Friends of Squaw Valley

Recommendations to DRC Village at Squaw Valley Design Guidelines

Revised for 5/1/14 DRC Meeting

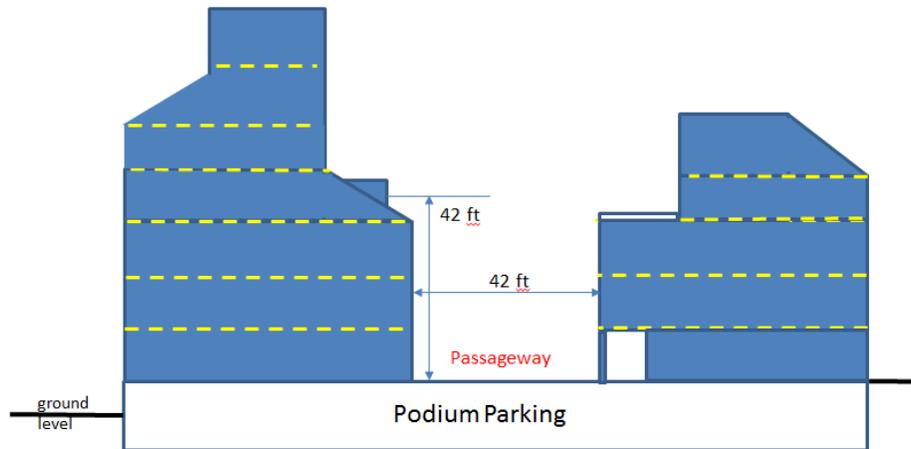
The drawing below seeks to illustrate this point a bit further. The face of a building fronting on a plaza or passageway must not be taller than 3 ½ floors. The face of a building fronting on parking areas, courtyards, paths, or other “open space” does not have such limits. So in this drawing, the left hand building has a 4th floor slanted roof (with dormer window) softening the vertical rise on the face fronting the passageway. The building on the right has a 3 floor rise, but a terrace on top of the 3rd floor. The other face of each building has no such restrictions.

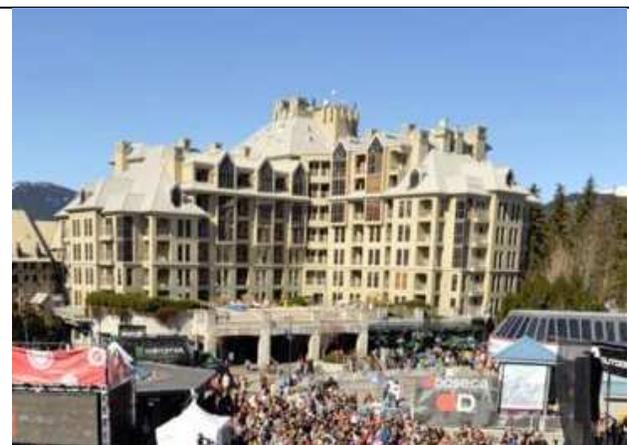
Here are views of the Pan Pacific Mountainside in Skiers Plaza at Whistler that illustrates this concept. Stepping reduces height impact from the maximum six stories, dropping to one and two stories at the mall level.

In this view, the stepping of the building is clearly evident. The non-stepped faces of the building are allowed as these faces do NOT front onto any passageway or public plaza.

In this view, the stepping is less apparent, but the building steps down to one and two levels adjacent to, and is recessed away from, this public plaza.

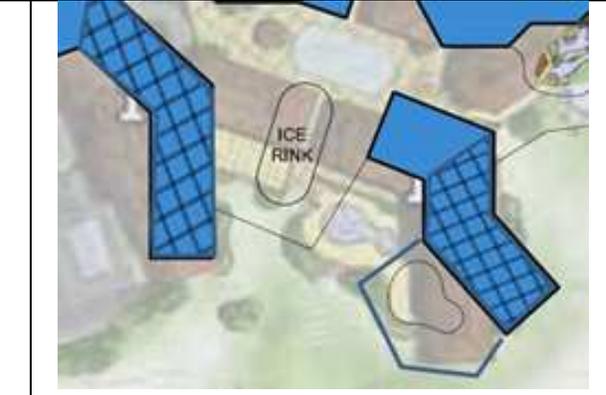
To illustrate this point, consider the buildings around the ice rink in the current illustrative concept diagram, shown in the left hand image below. North is to the top of both images.

<p>The E-W orientation of the buildings to the south of the plaza will cast long shadows during the winter months, when the sun is low in the sky.</p>	<p>By rotating the buildings and the rink to a more N-S orientation, the plaza is open to the sun as well as the views to the mountain to the South.</p>

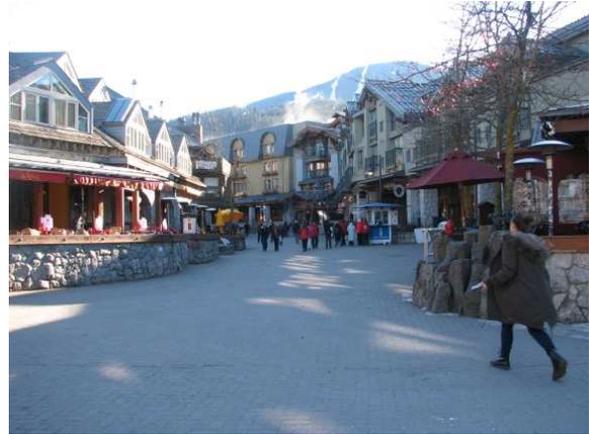
From item #2, the recommendation is that the height of any building fronting on any pedestrian passageway or public plaza shall not exceed 3 ½ stories (42 ft.). If the building is to be taller, then the recommendations of stepping-back come into effect. To illustrate this “Sense of Enclosure” point, here are three examples.

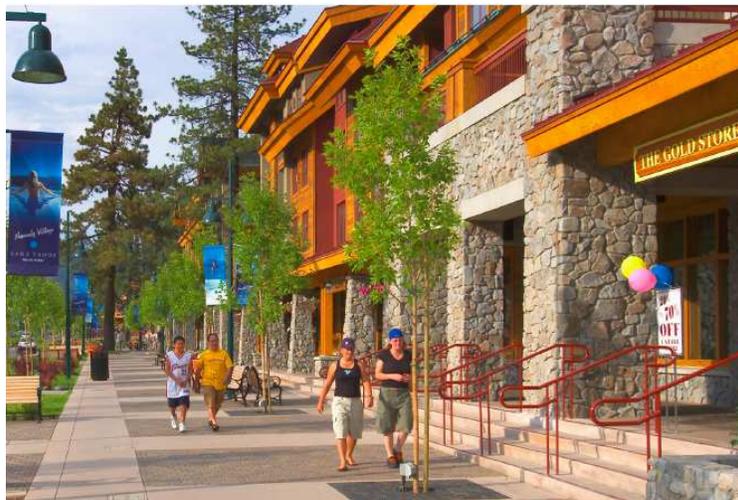
Good: (L) old Vail. (R) Village Stroll from Village Square (Whistler). Buildings are up to 3 ½ stories, approximately same width as passageway, with the fourth story in the roof. Notice detailing at the pedestrian level.

Bad: Even though the passageway is 50' wide, a 5 story structure feels intruding. Stepping the structure so that the maximum is 3 ½ floors at the passageway would have a dramatic opening feeling. Furthermore, there is no use of varied rooflines, balconies, architectural details, window treatment and dimensions, canopies, nor pedestrian level detail.

Very Bad: This is completely unacceptable. (Image is at the main entrance to the ice rink at Northstar). Note how overwhelming the buildings feel even though the walkway is almost 50' wide. Notice also the shadows that will be there all year.
